STA100

SCHEMATIC FOR MAIN PCB

ECO # 0011017

9906094

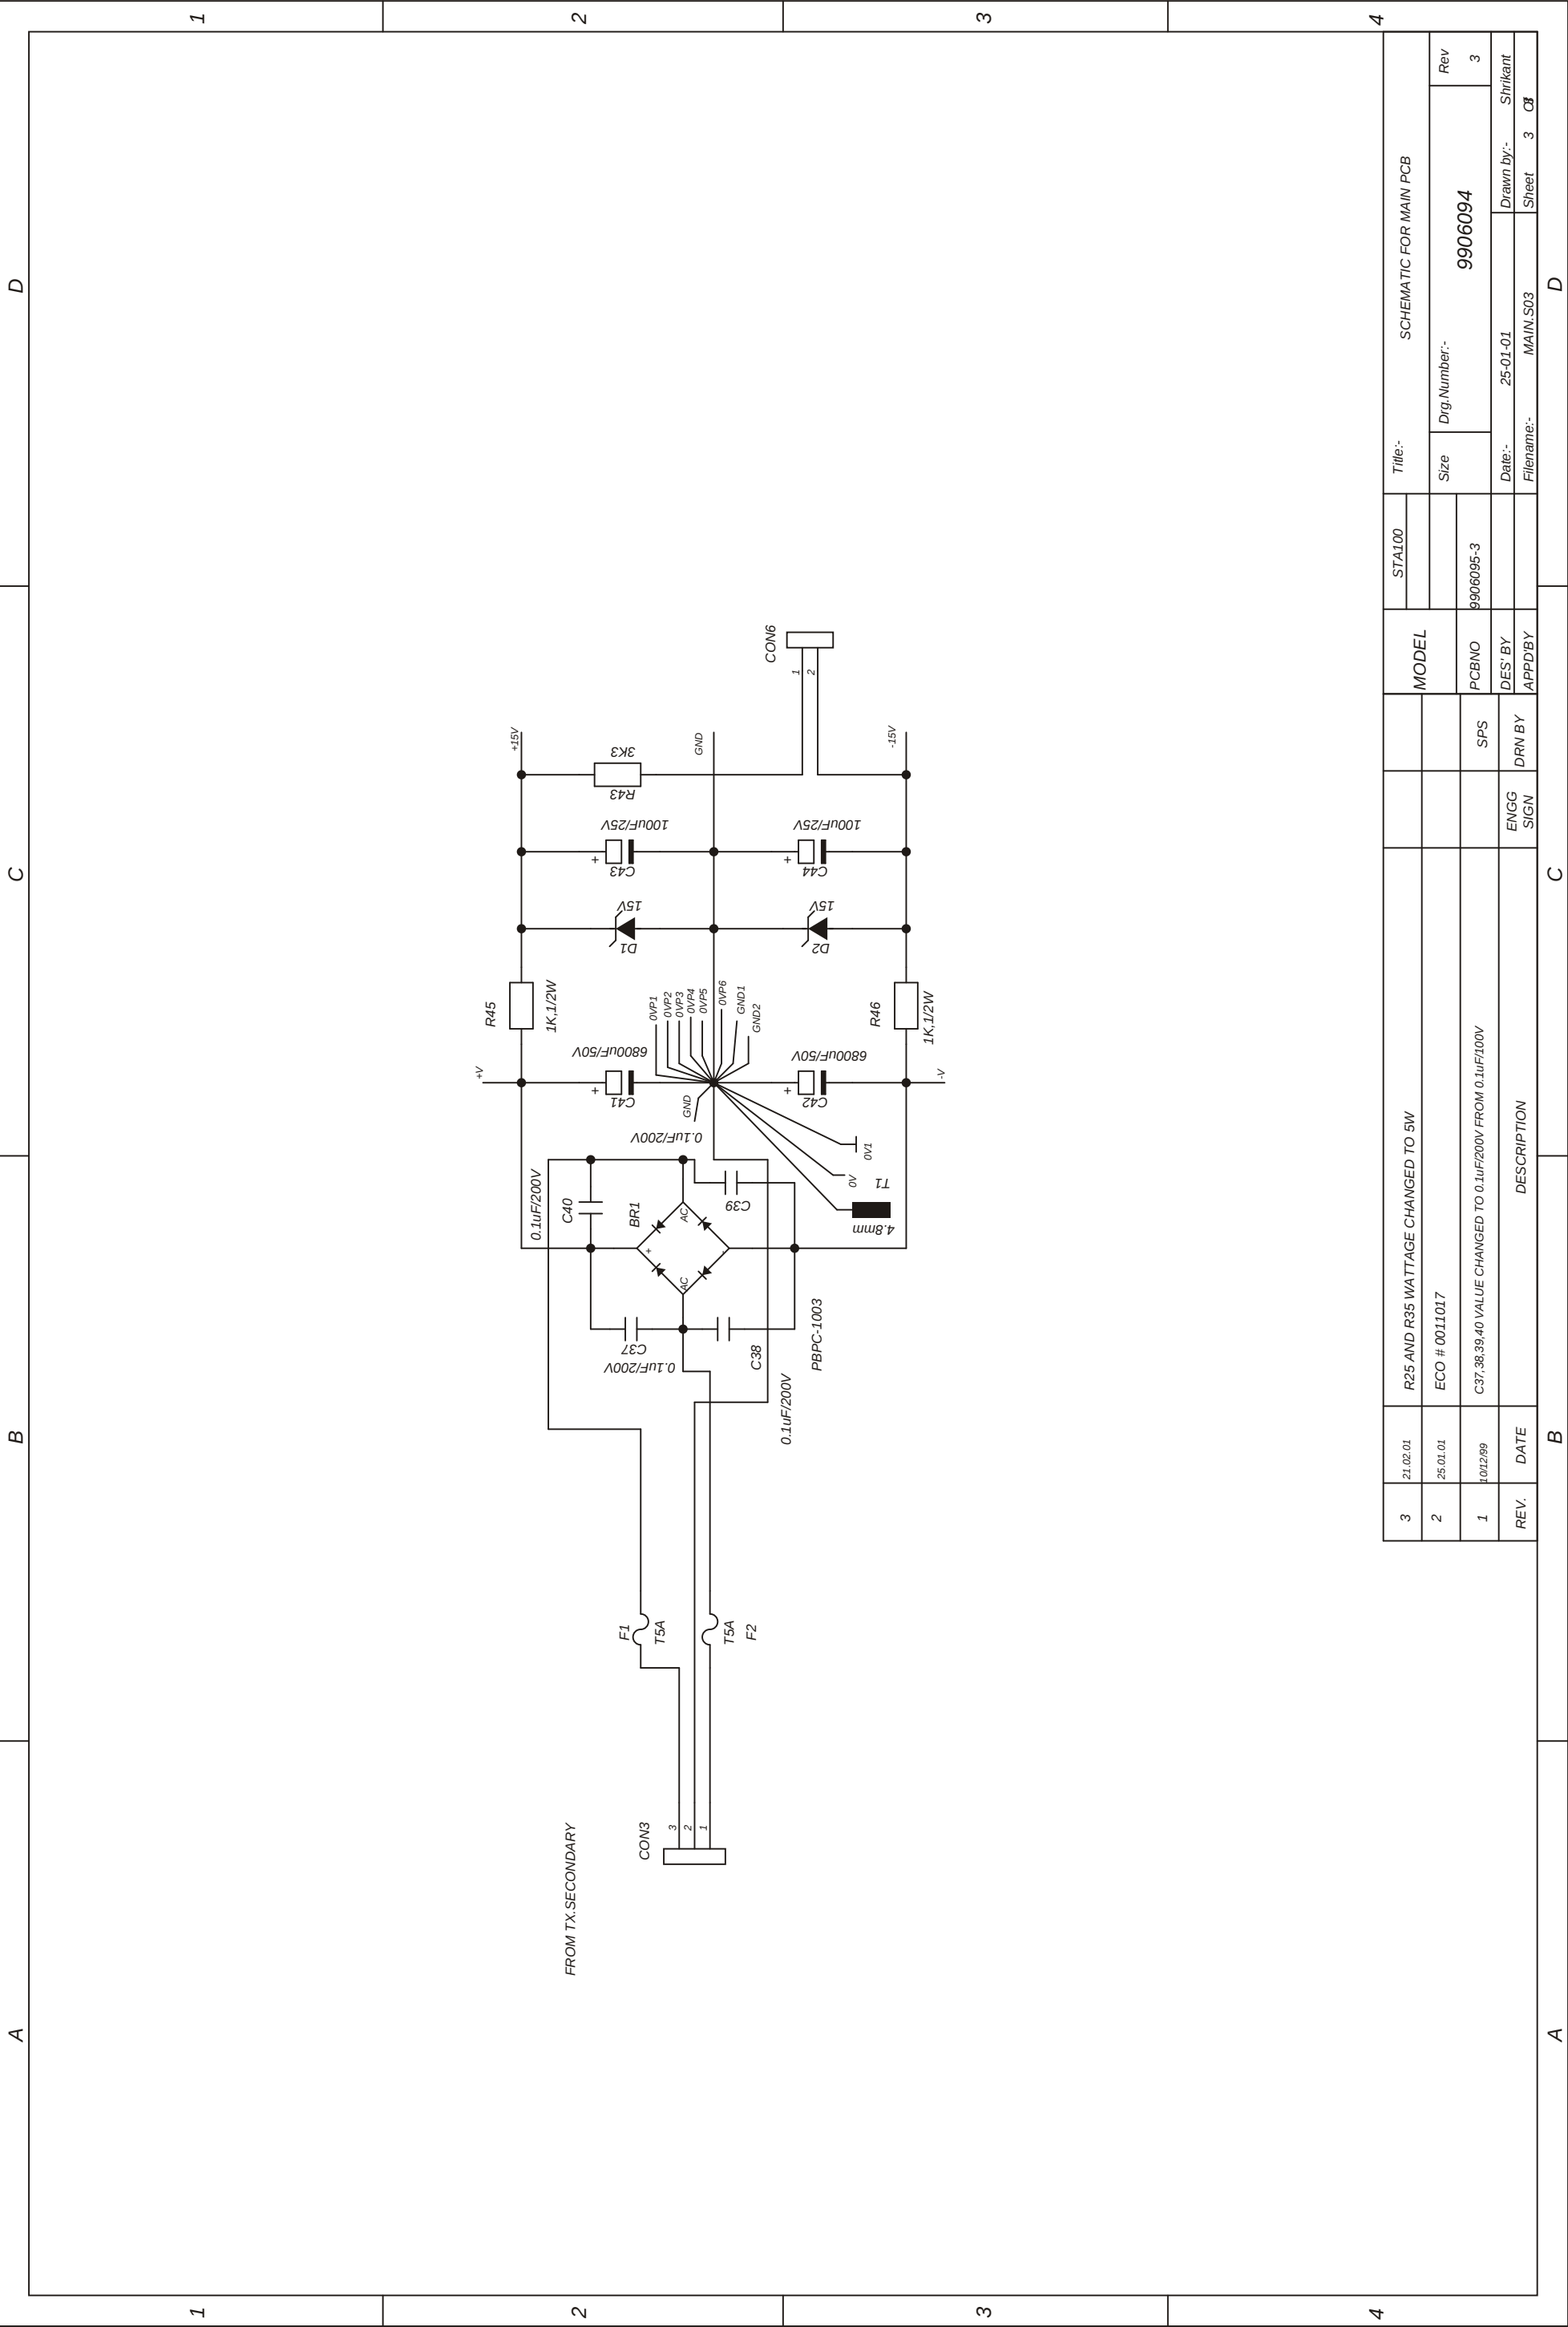
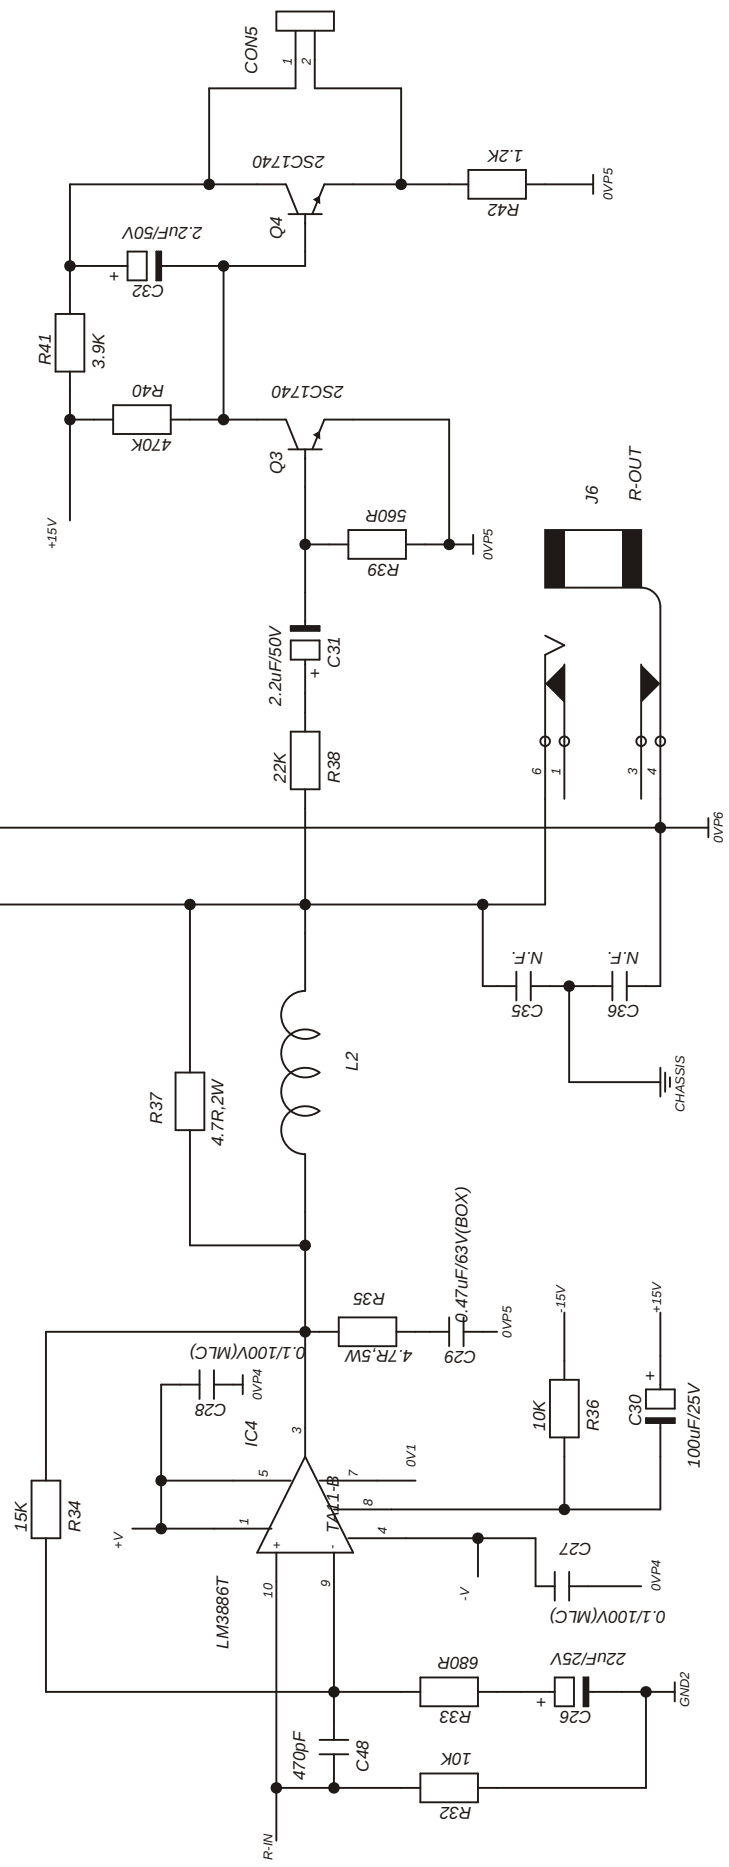
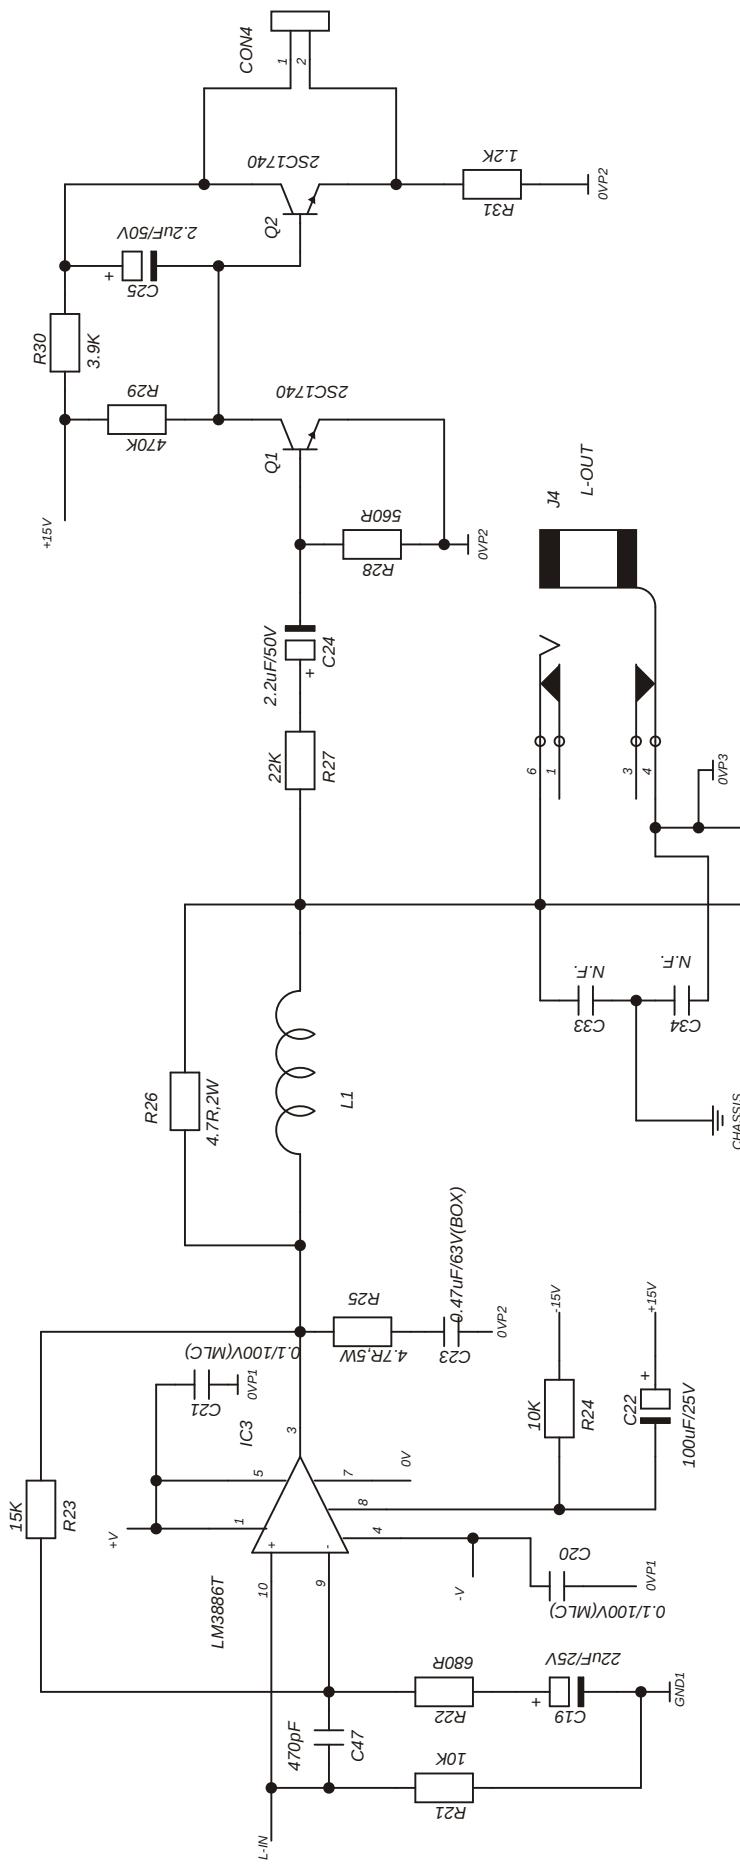
R25 AND R35 WATTAGE CHANGED TO 5W

C37,38,39,40 VALUE CHANGED TO 0.1uF/200V FROM 0.1uF/100V
